ERCOUPE
SERVICE
MEMORANDUM

No. **42**

SUBJECT: Rerouting of Fuel Pump Lines

FIG. 1

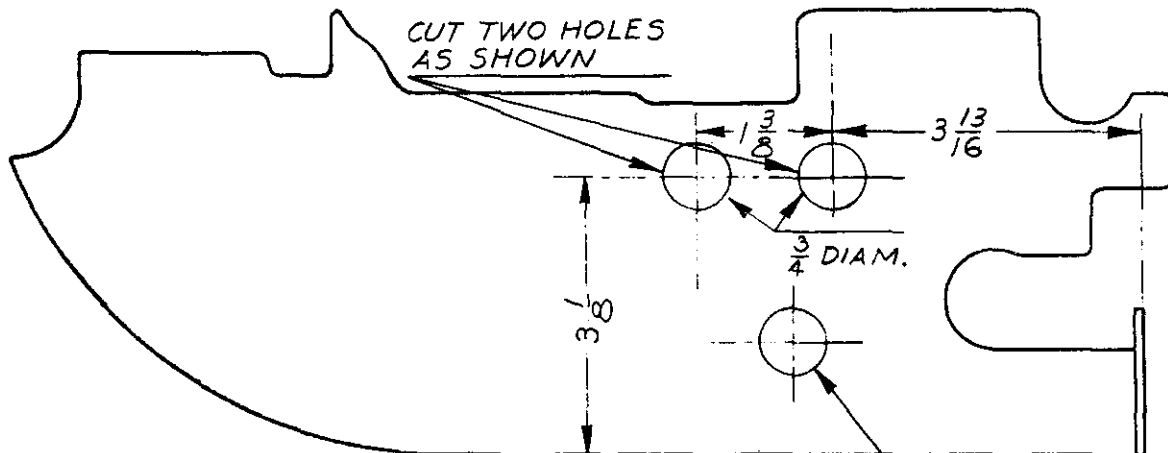
4. Reworking of Right Front Engine Cooling Baffle: (Ref. Page 3, Fig. 1)

1. Mark two holes in baffle as illustrated in Fig. 1, Page 3.
2. Drill two 3/4" diameter holes at the above marks.
3. Install two elastic grommets (AN931-9-13) into the new holes.
4. Snap button plug (415-40589-1) into the extra unused hole.

INSERT BUTTON PLUG
(PART No. 415-40589-1)
IN EXISTING HOLE

MODIFICATION OF RIGHT FRONT
ENGINE COOLING BAFFLE
(PART No 415-40403)

(For replacement, order Engine Cooling Baffle (Part
No. 415-40569))

RELOCATION OF FUEL
PUMP & FUEL LINES
FIG. 2

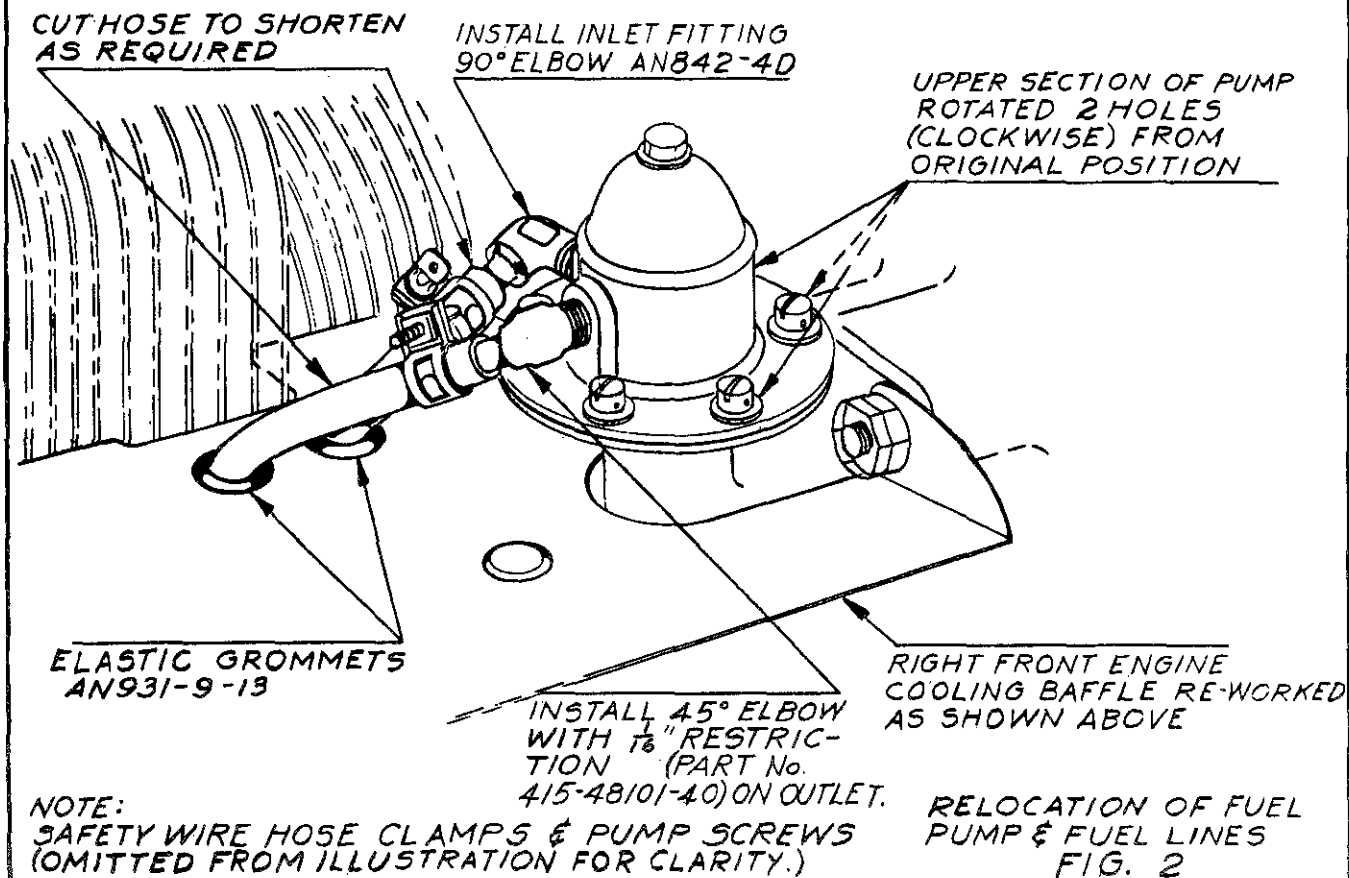
Failure of a fuel pump pressure line, due to chafing on the nose cowl has resulted in a change in the routing of the fuel pump lines. This change was effected at serial number 3643. Ercoupes up to and including serial number 3642 having fuel pumps incorporating metal filter bowl and bearing the AC part number 1539076 on the mounting flange, will be affected by this memorandum. The fuel pumps which use a glass filter bowl (AC 1523843 and AC 15339051) are not affected. It is recommended that this memorandum be complied with at the next 100 hour check because there is a possibility of an eventual failure of this line if not modified. Inspection at each 25 hour check for chafing should be made until modification is effected.

a. Disassemble and rework fuel pump as follows: (Ref. Page 3, Fig. 2.)

1. Cut safety wire and remove the six screws joining upper and lower halves. There will be considerable spring pressure when removing the last screw.
2. Check the condition of the diaphragm while pump is disassembled. All fuel pump parts necessary for repair are available from the Continental Motors Corporation, and AC Automotive Service Stations.
3. Rotate top of pump 120° clockwise (two screw holes from the original position).
4. Reassemble pump halves with the six original lockwashers and screws.
5. Safety screws with brass safety wire, American Steel & Wire Gage No. 18 (.041 dia.)
6. Replace pump inlet port fitting with AN842-4D elbow, using Parker Sealube (6PE) on threads.
7. Replace pump outlet port fitting with 415-48101-40 elbow having 1/16" restriction, using Parker Sealube (6PE) on threads.

- a. Install fuel pump and cooling baffle as follows:
 - 1. Insert fuel pump hoses through respective holes, with grommets, in cooling baffle.
 - 2. Install fuel pump being certain that wobble arm lays on top of cam-lobe inside of crankcase.
 - 3. Install nut and washer on rear pump mounting stud.
 - 4. Place cooling baffle, and attach to front pump mounting stud with nut and washer.
 - 5. Install Palnuts on both pump mounting studs after the nuts are tightened.
 - 6. Shorten outlet hose (415-48201-3) as necessary to permit strain-free installation.
 - 7. Install fuel pump hoses (415-48201-3) onto respective elbows.

- 8. Secure with two hose clamps (AN746-4) and safety clamps with brass safety wire, American Steel & Wire gage No. 18 (.041 dia.)
